PLG-0367
Revised

SOUTH TEXAS PROJECT PRELIMINARY SCOPING STUDY RESULTS

Prepared for
HOUSTON LIGHTING AND POWER COMPANY
Houston, Texas
May 1985

FIGURE 5-3. ESSENTIAL
COOLING WATER SYSTEM PIPING
AND INSTRUMENTATION DIAGRAM

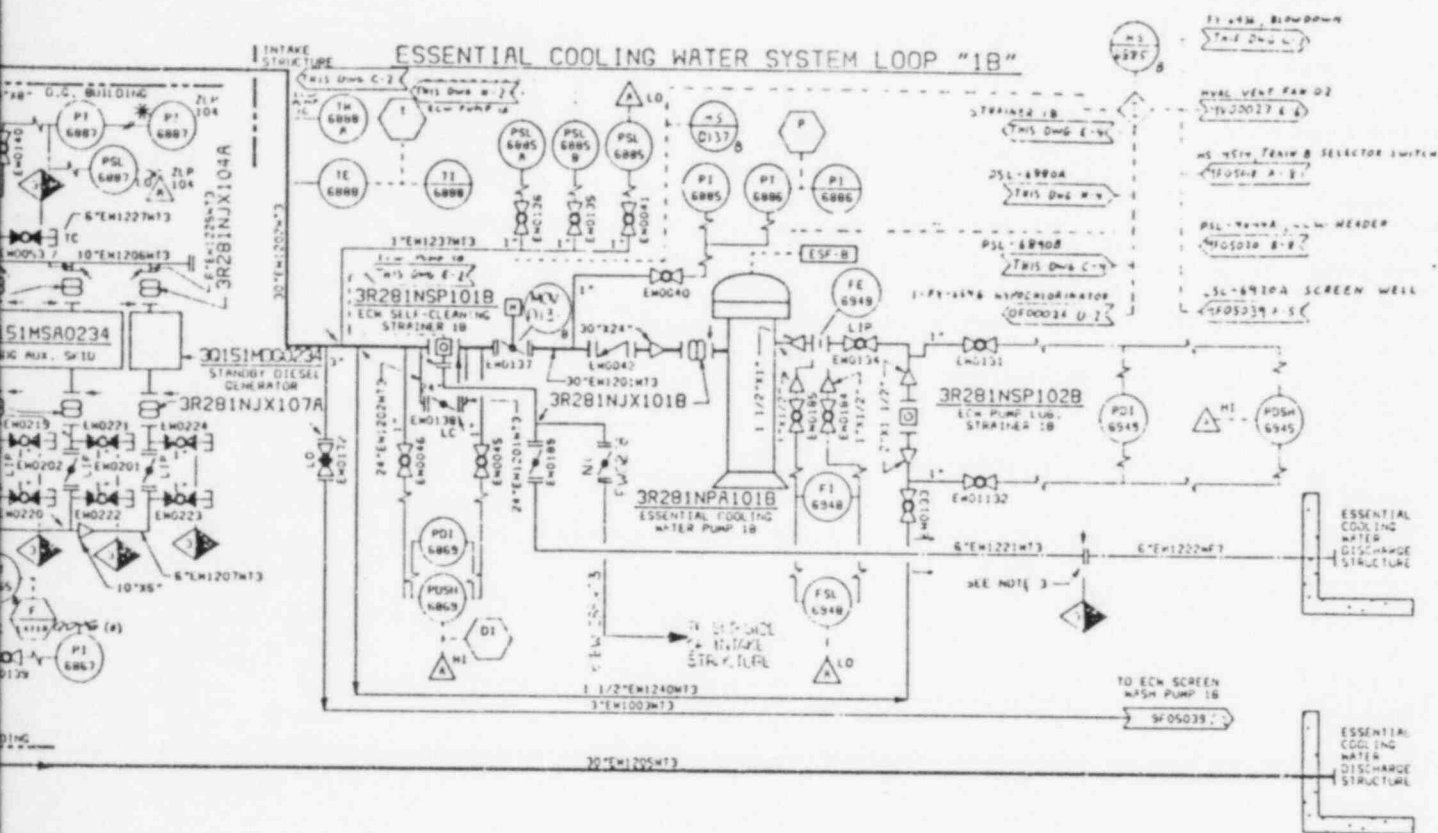
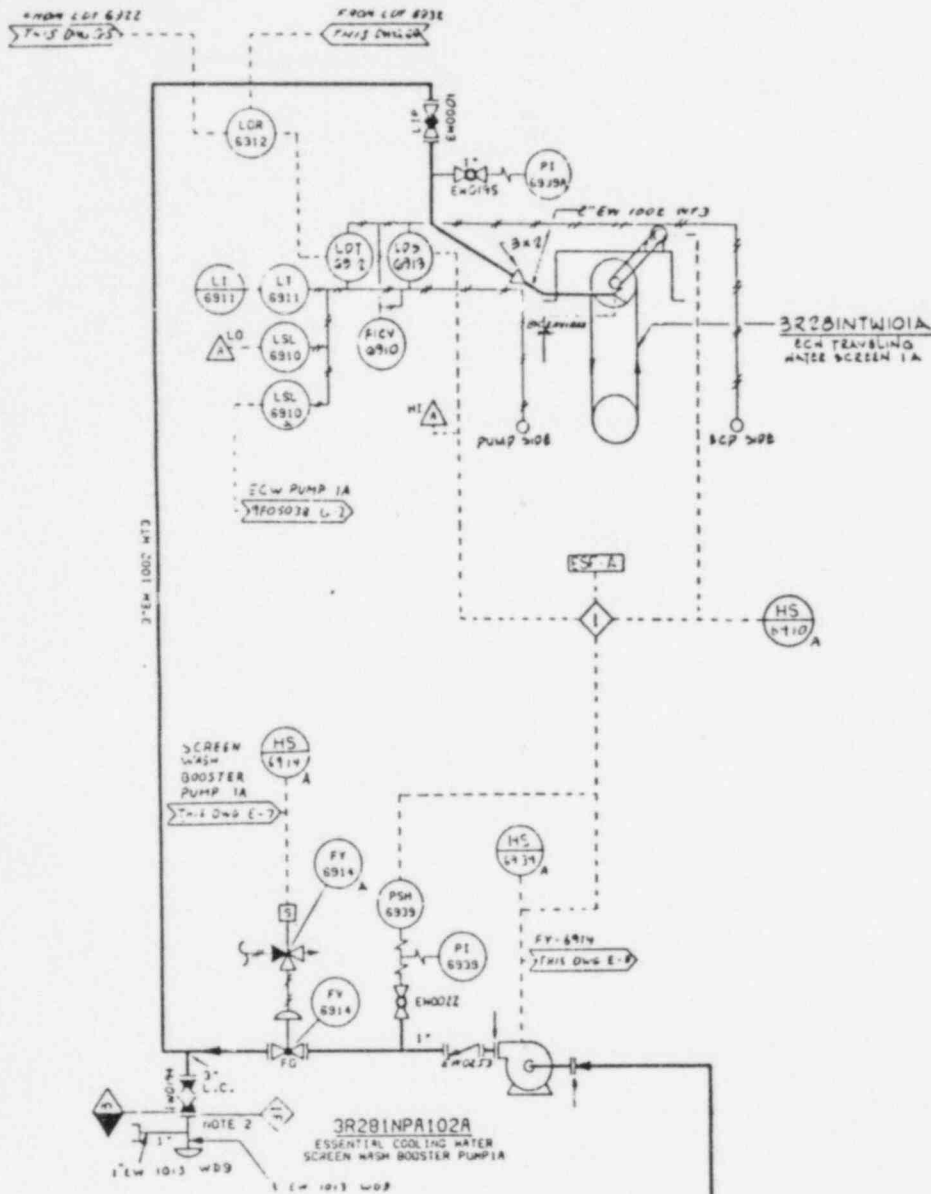
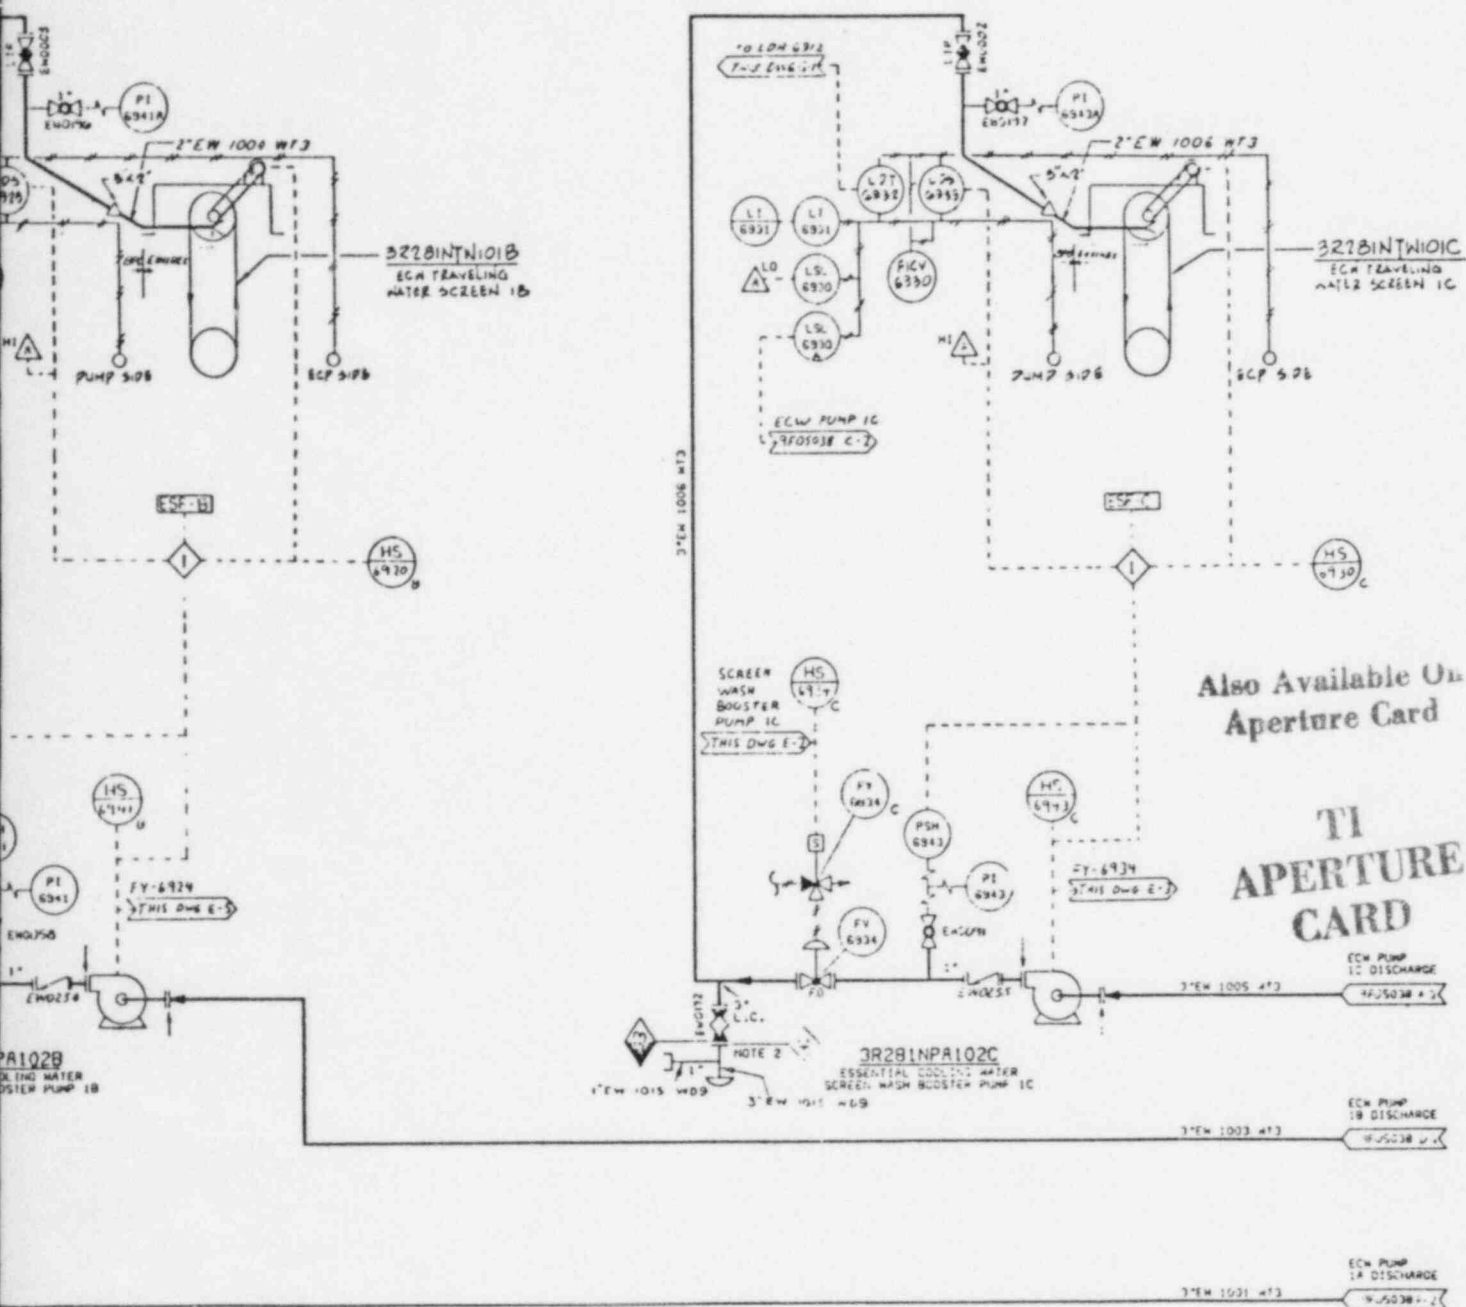
Pages 5-18 and 5-19, Figure 5-3 - This Figure is not legible and should be replaced. PLG should take necessary steps to assure the legibility of all tables and figures. Foldouts should be used if necessary.
